## **AMENDED APPLICATION CLASS 1**

Planning law – application to modify development consent granted by the Court (s 4.55(8)  
*Environmental Planning and Assessment Act 1979*)

Application to modify the development consent to DA55/19 for the land at 5 Bay View Street, Lavender Bay granted by the Land and Environment Court on 3 September 2020 by *Camuglia v North Sydney Council* [2020] NSWLEC 1406 (proceedings 2019/268493) which approved the demolition of existing structures and construction of a new residential flat building containing three units, a new garage structure and associated works (**the approved development consent**).

The Application seeks the ~~removal of the step in the roof and the~~ deletion of condition A2 of the approved development consent which requires the roof ridge height and surrounding parapet for the structures at Bay View Street level, comprising the car lift, visitor's car space and pedestrian entry lift and stairwell, be reduced to RL 22.00.

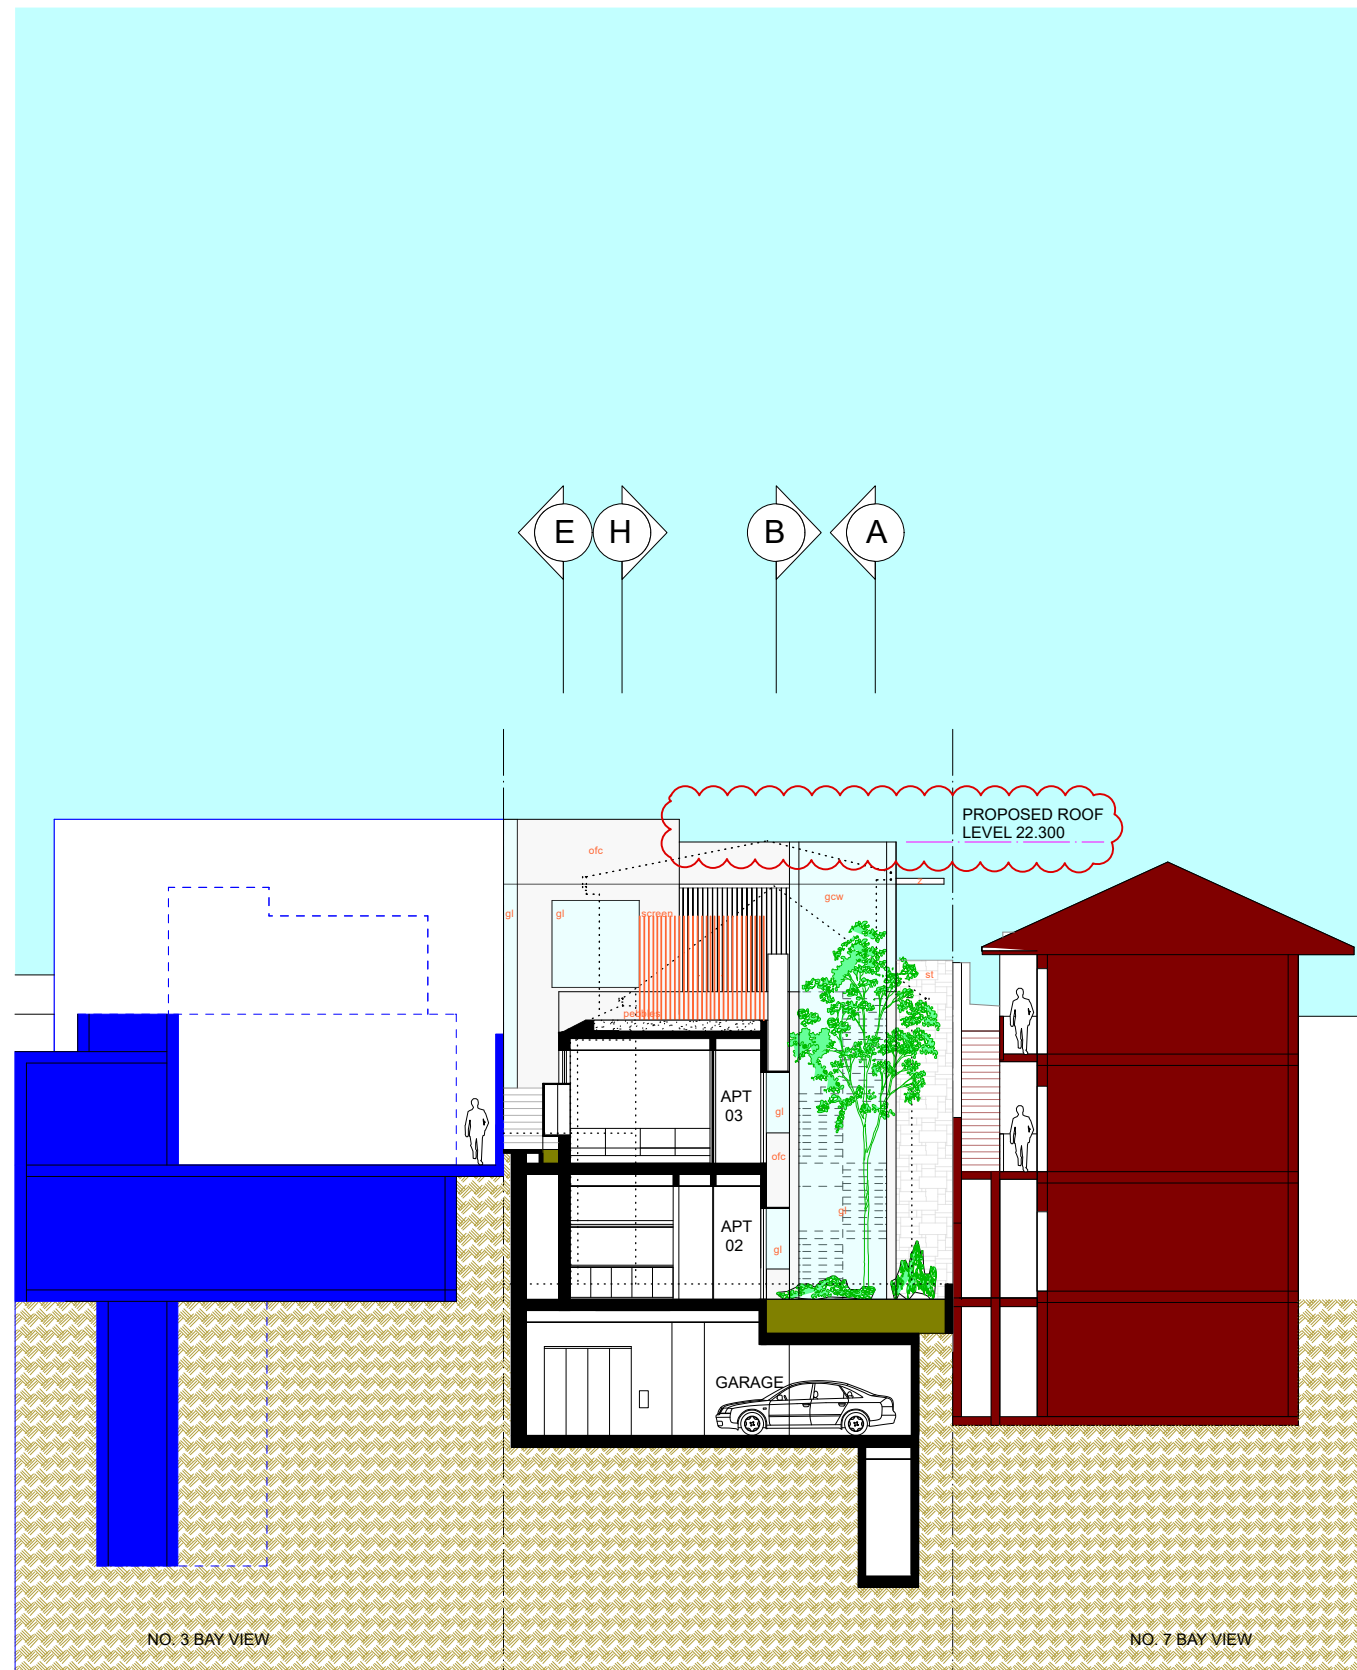
INDICATES REVISIONS TO ALIGN WITH  
 DA55/19 APPROVAL CONDITION A2

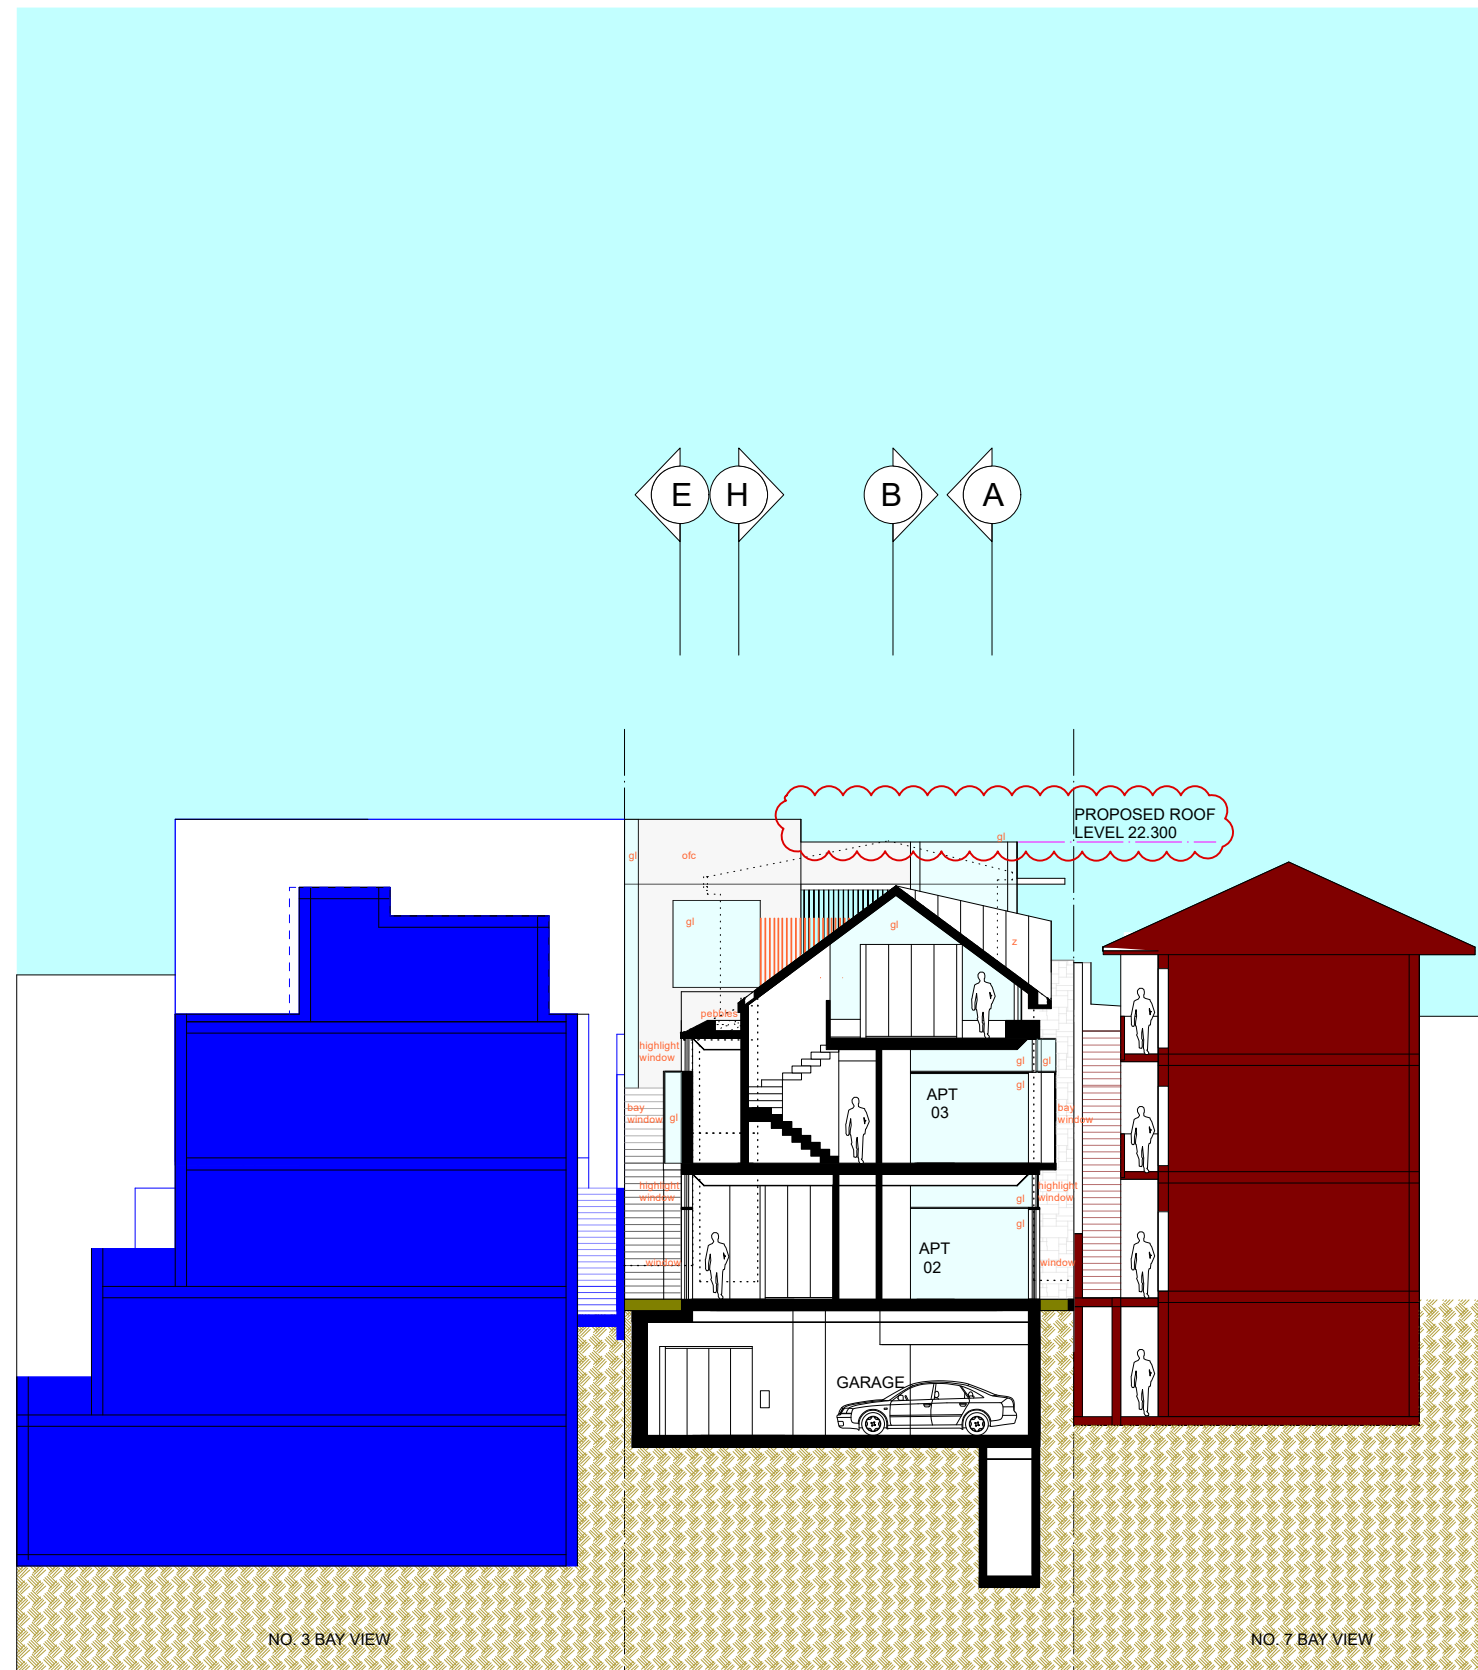
INDICATES REVISIONS TO ALIGN WITH DA55/19 APPROVAL CONDITION A2
